FOUNDATION
BARN/BUNKHOUSE
LONESOME BEAR RANCH
SOUTHERN COLORADO

SLAB PLAN & DETAILS

BARN & BUNKHOUSE

SHEET 2.5 OF 36-D

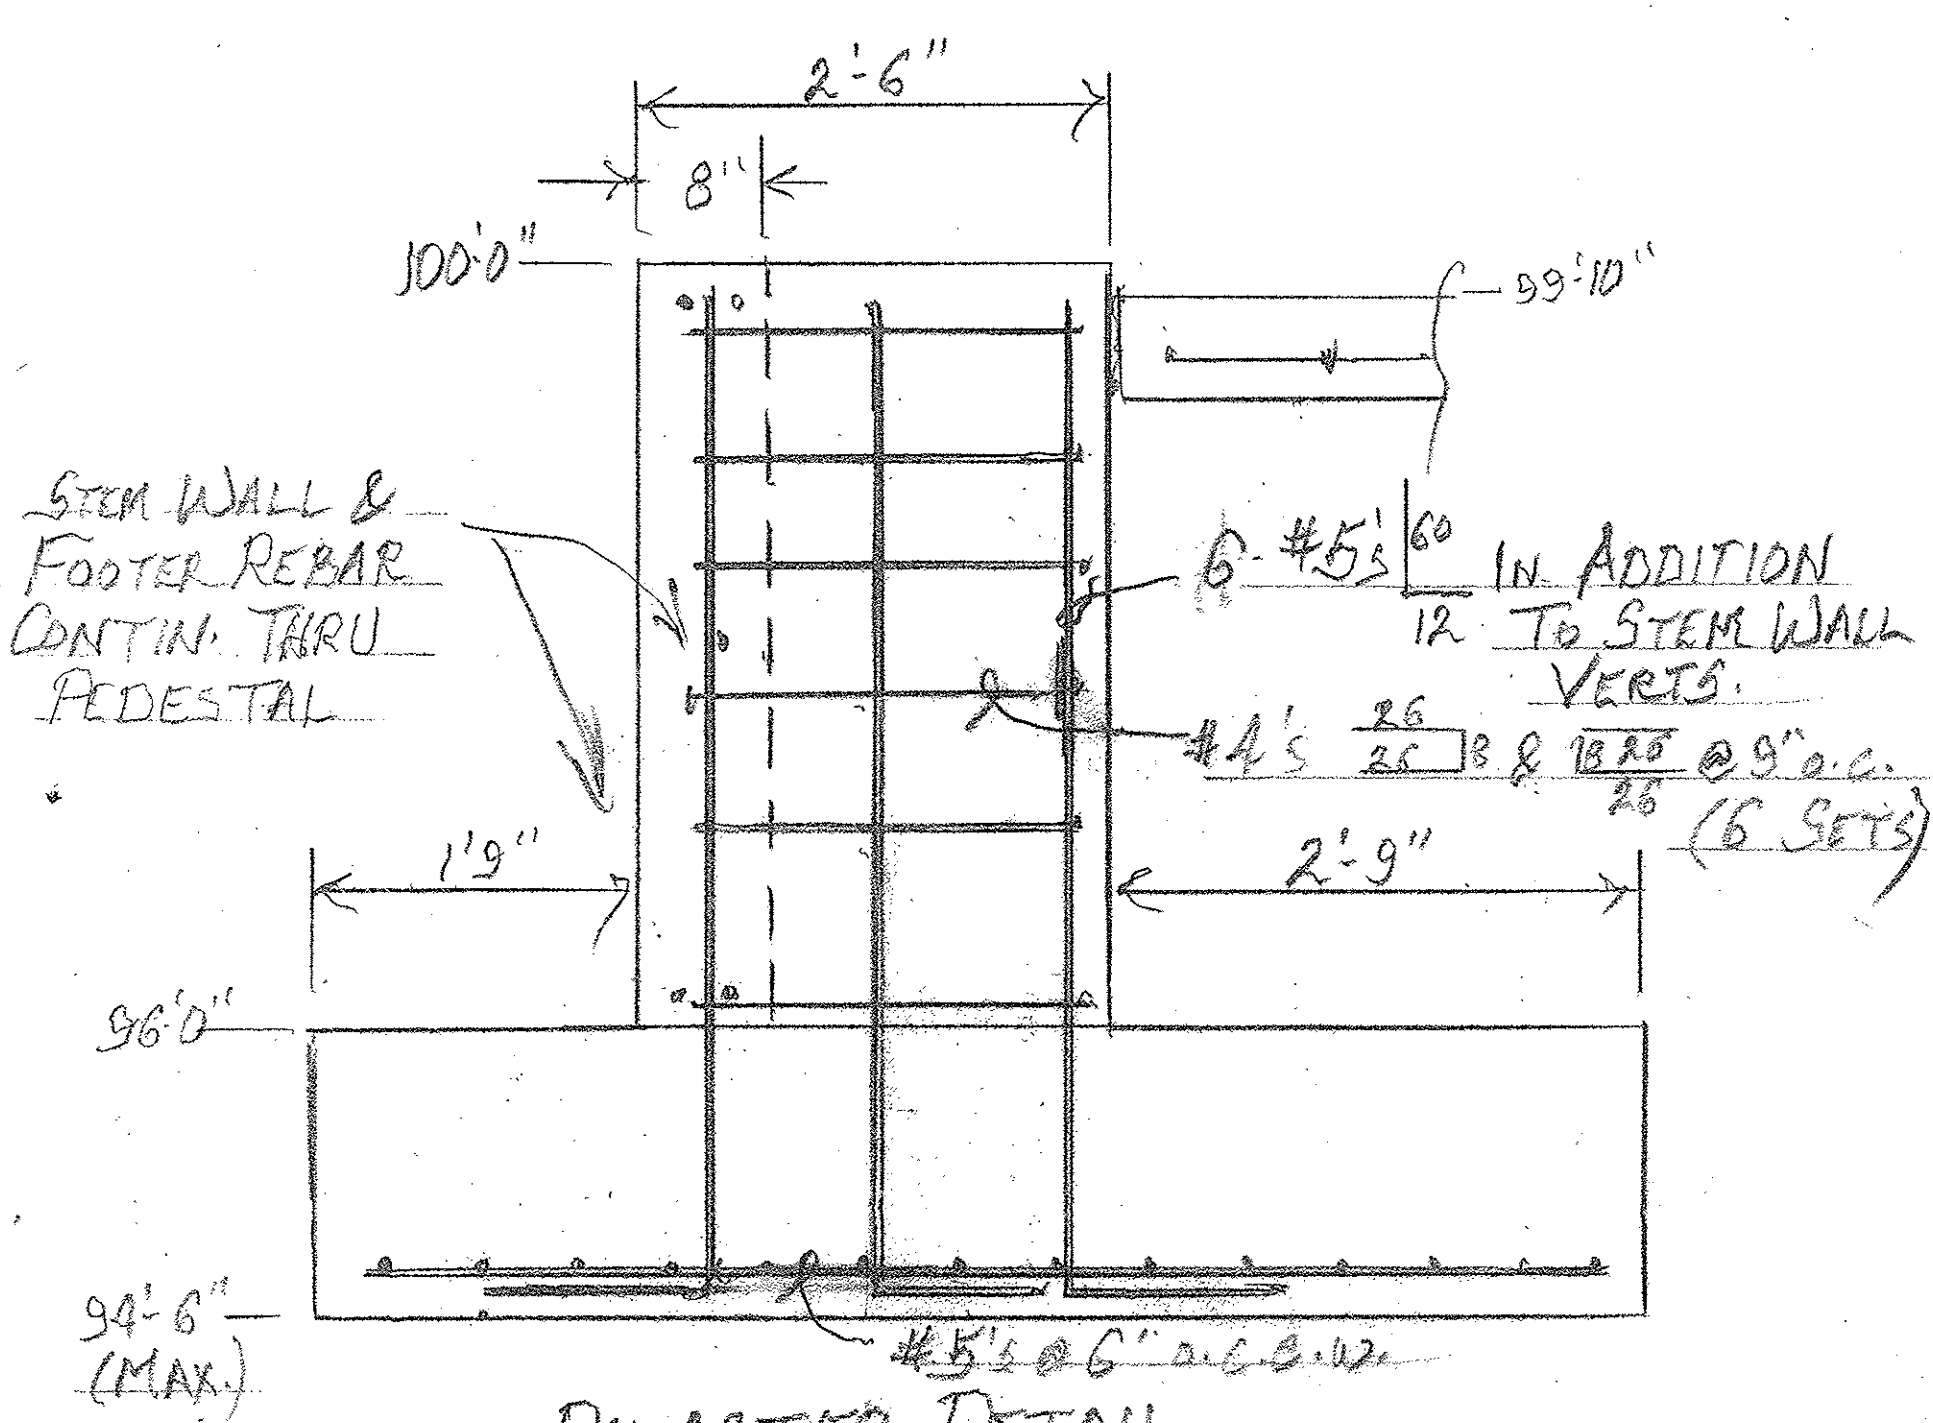
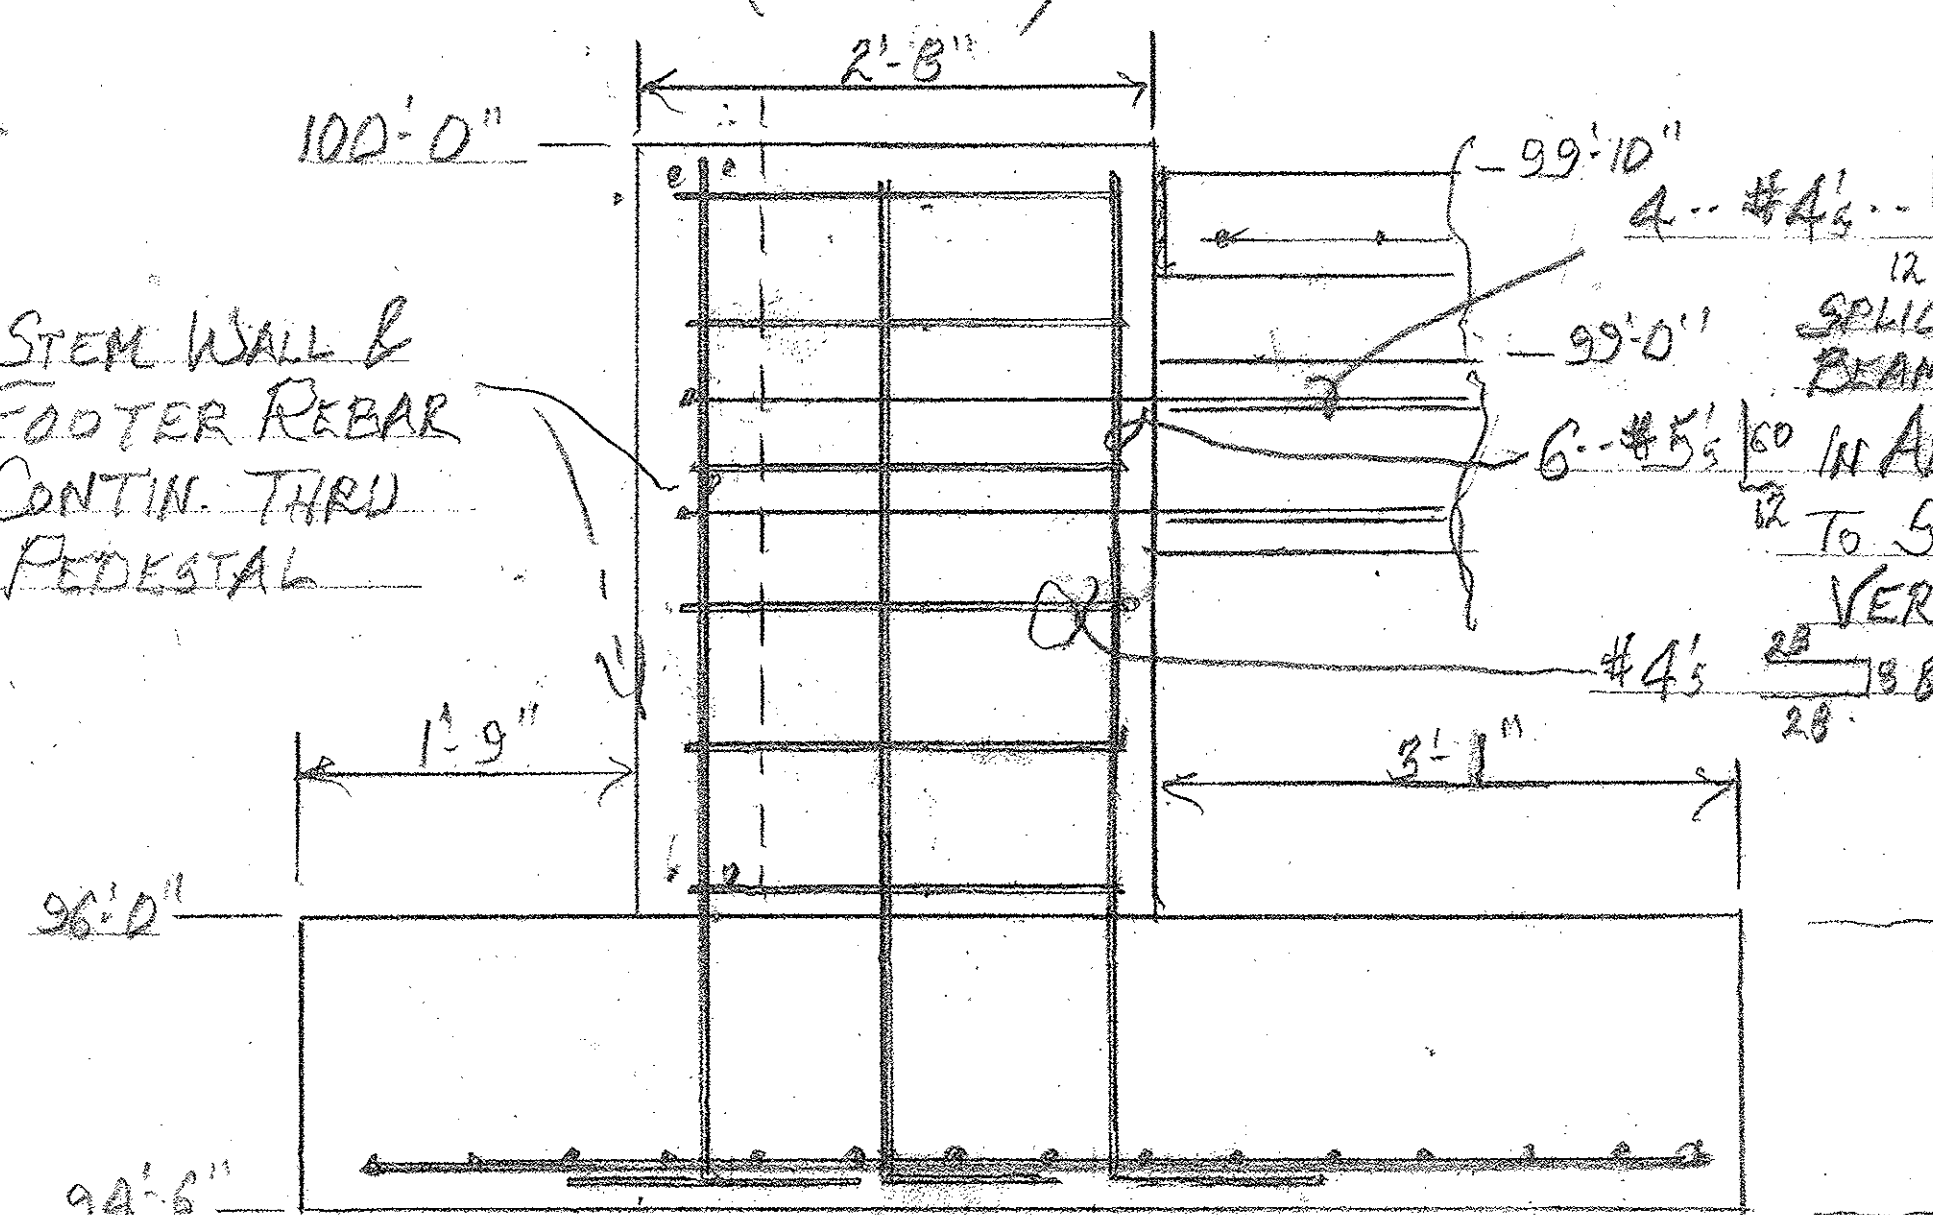
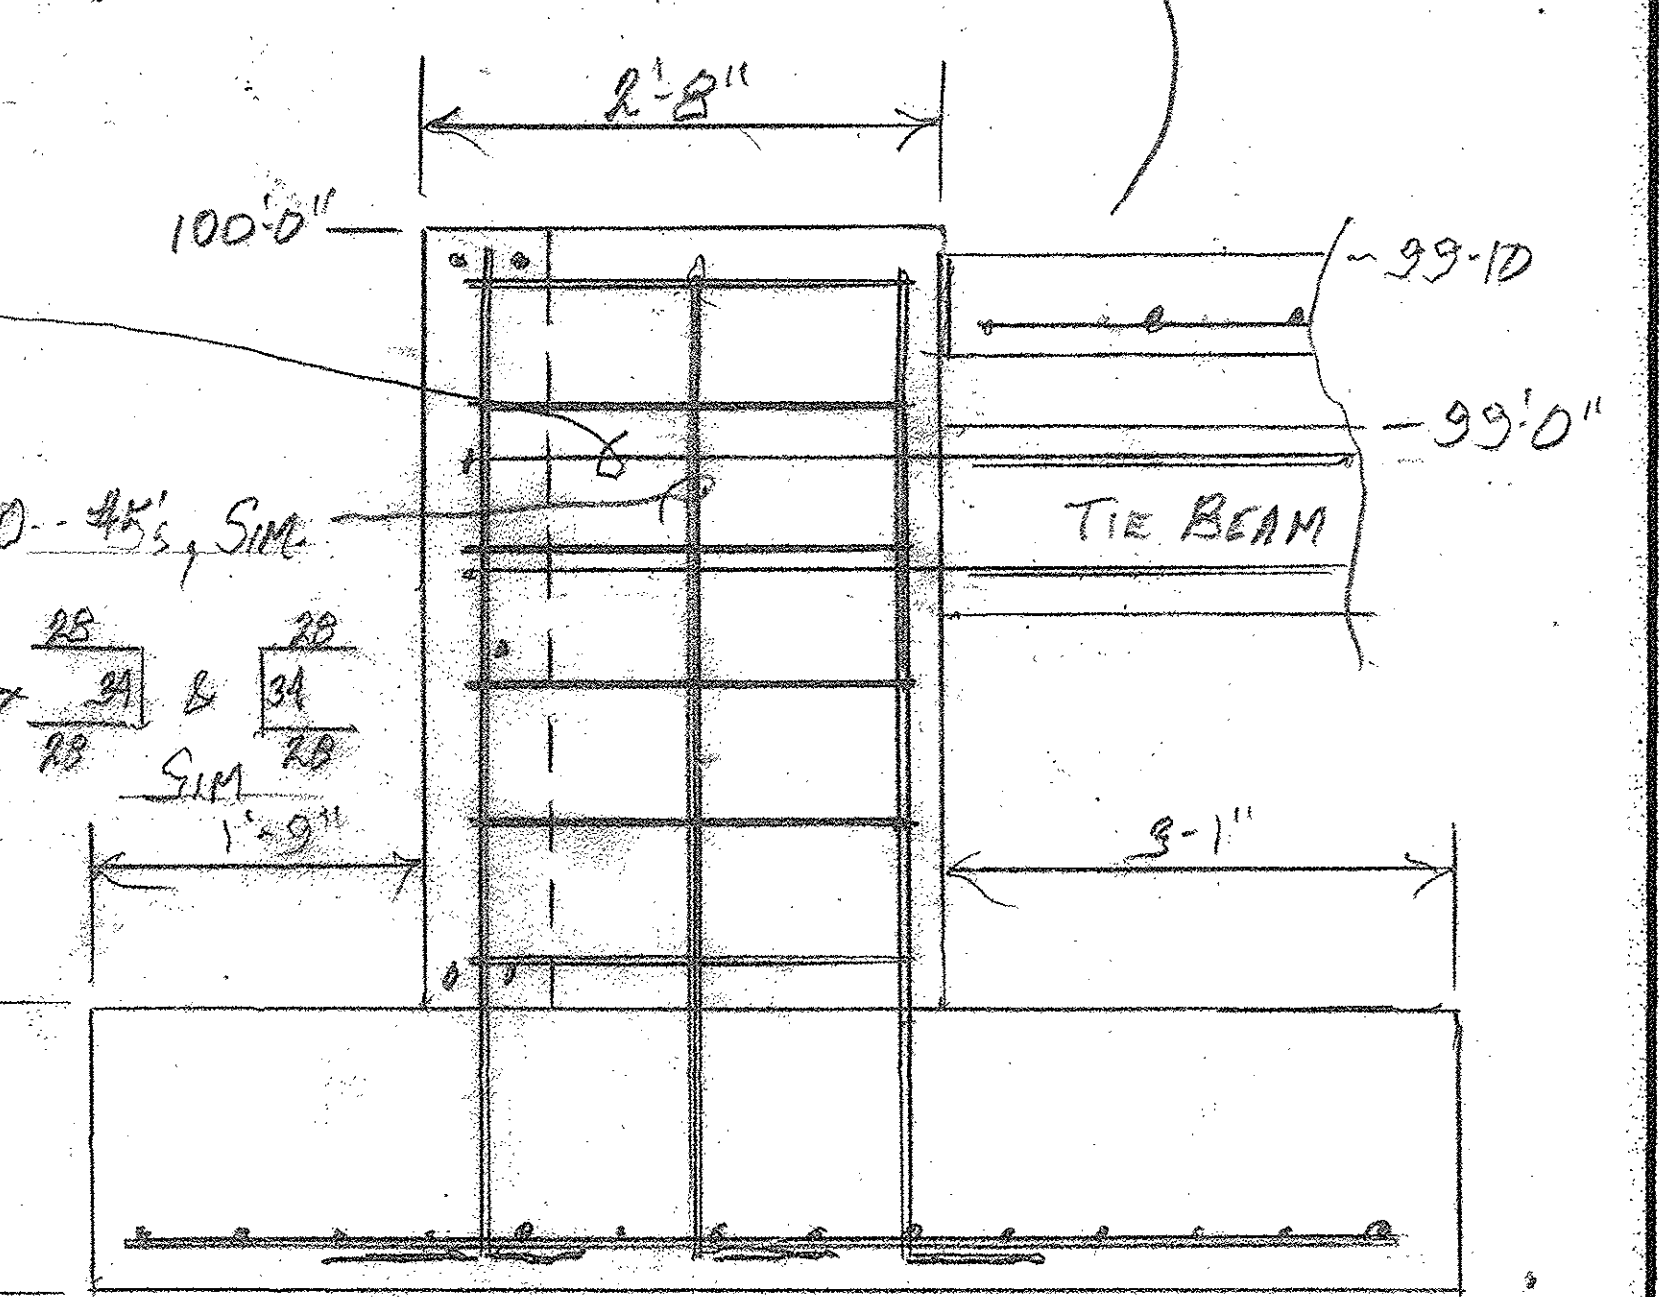
Per our discussion this afternoon, Mike and I will be working with Scott Myller in order to address all of the issues you have raised with respect to occupancy separation and other 'upstairs' issues in the subject building.

The anchor bolts will be as follows:

3/4" D., imbedded in the pilasters (5 locations on each side) will be 36" long with a 4" right angle hook at the bottom and 5" length of 3/4" D. UNC thread at the top.

3/4" D. imbedded in the end walls for end wall columns will be 18" long with a 3" right angle hook at the bottom and 5" length of 3/4" D. UNC thread at the top.

All 3/4" bolt shall be either of A-36 steel or meet the building manufacturer's noted 'F1554' spec, whichever is more stringent.
